# ARBORICULTURAL OPINION

## PROPOSED SUBDIVISION of 31 BELLARA AVENUE NORTH NARRABEEN

Statement prepared by Catriona Mackenzie

**28 July 2019**

### **TREE PLAN**

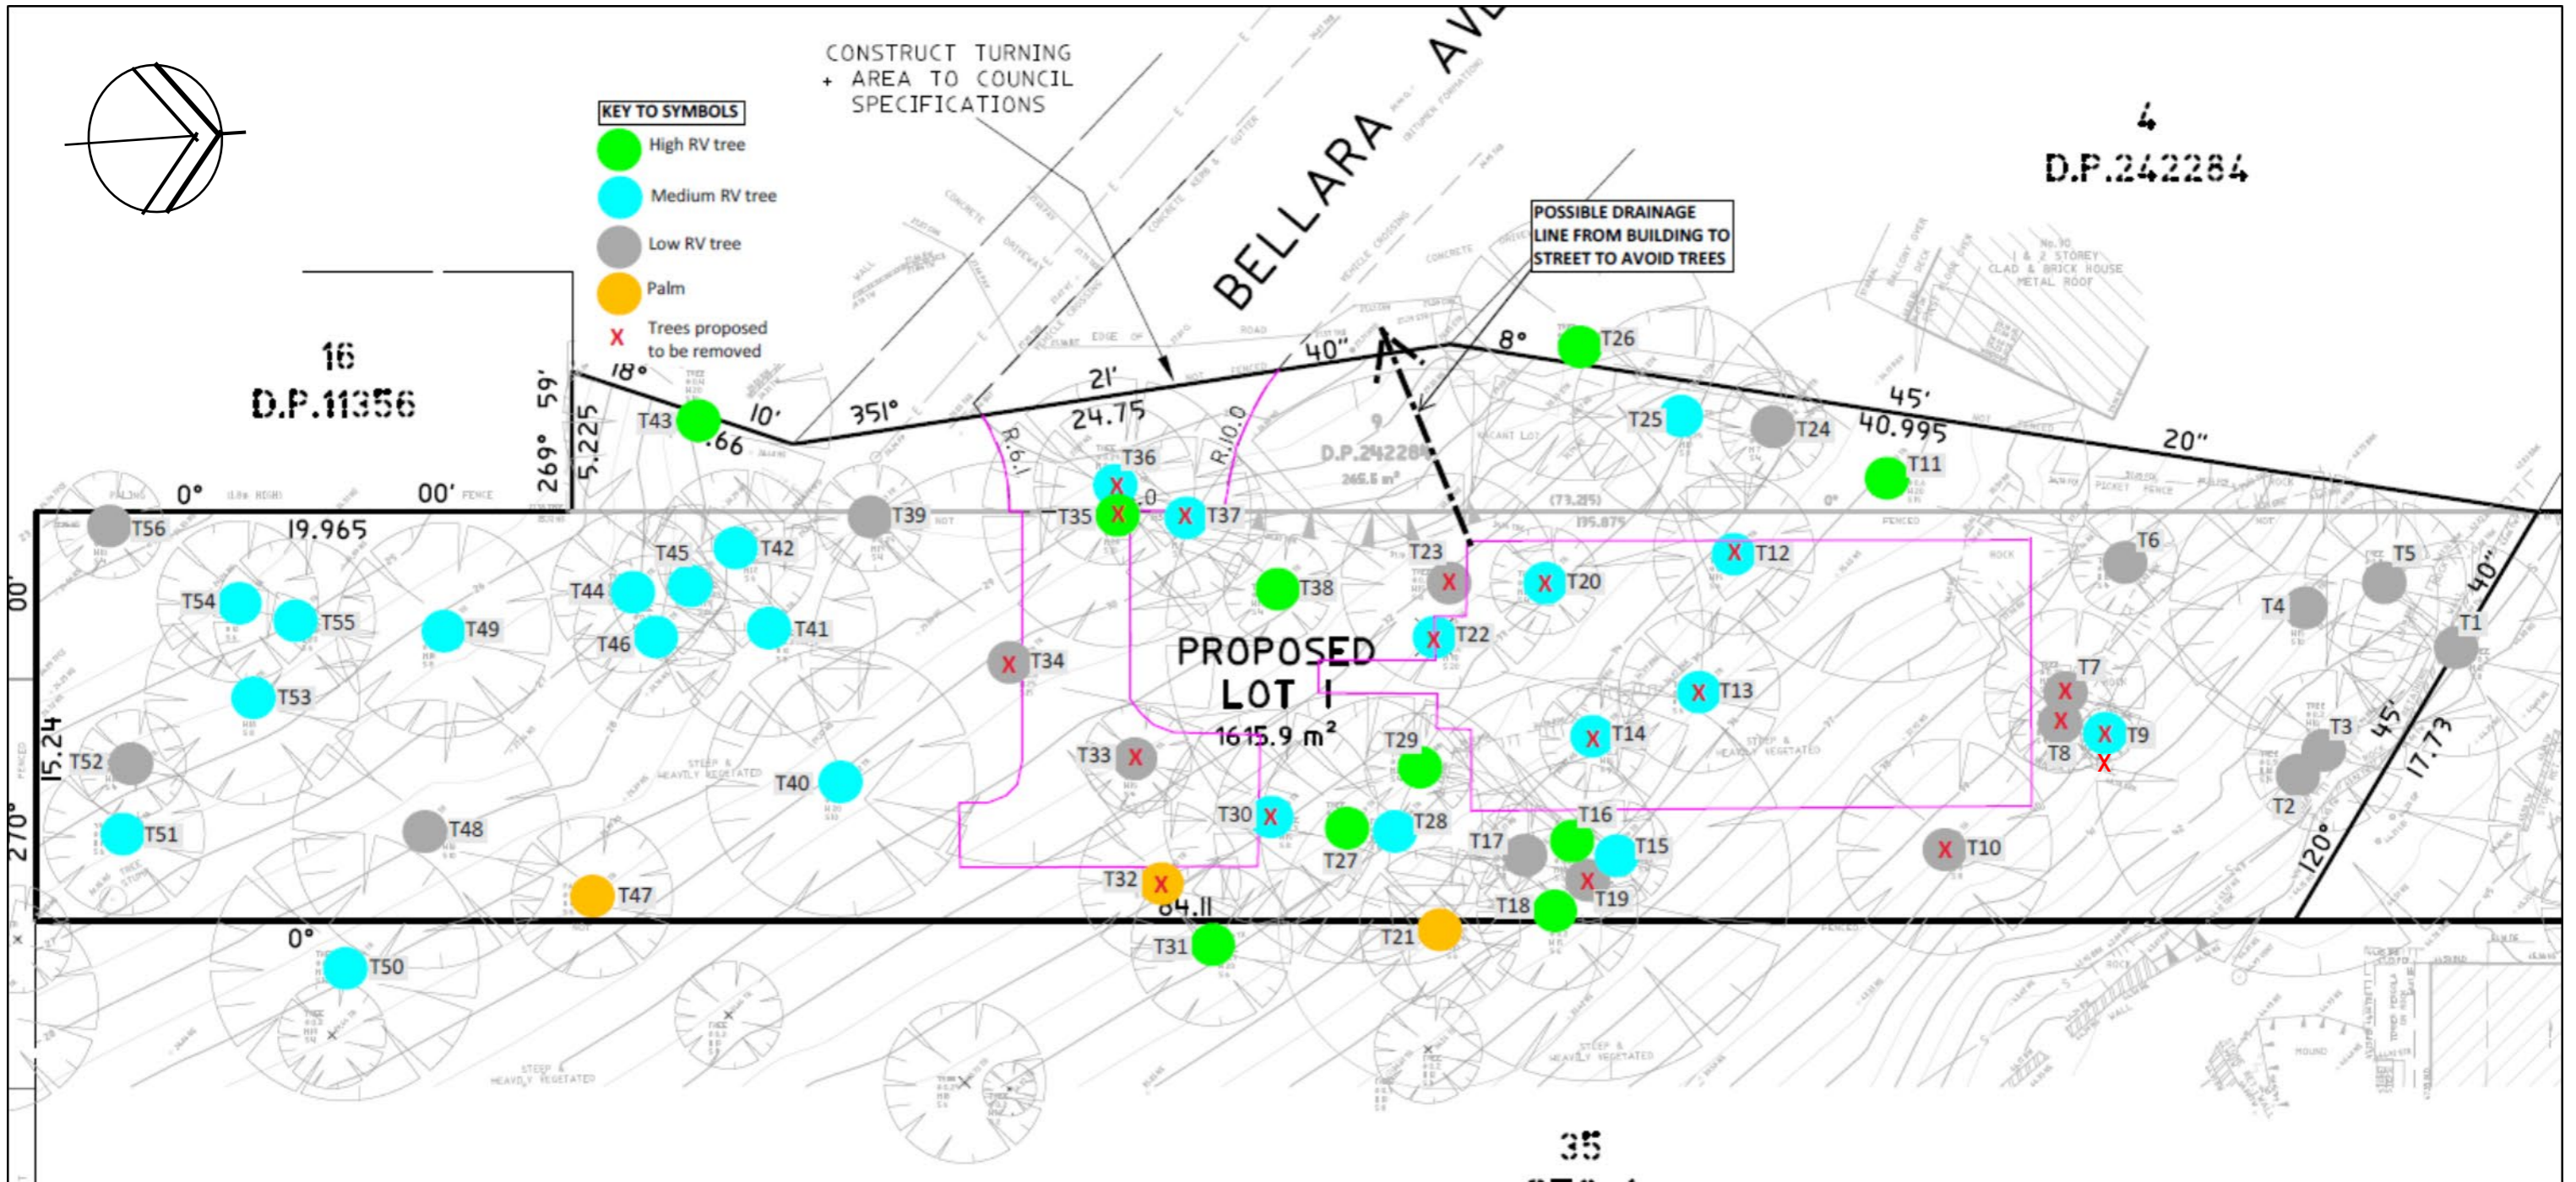
19. In regard to the draining of stormwater runoff from the proposed building to the street, and from an arboricultural perspective, please refer to the Tree Plan, Annexure C, for the proposed pipeline location.

**TREE PLAN** showing tree Retention Values (as amended by Catriona Mackenzie following site visits and tree assessments), and those trees proposed to be removed. The indicative driveway and building footprints are shown as pink outlines on the above plan.

Source: Excerpt of Survey Plan prepared by CMS Surveyors, dated 25/03/2019, marked up by C. Mackenzie. July, 2019. Not to scale.
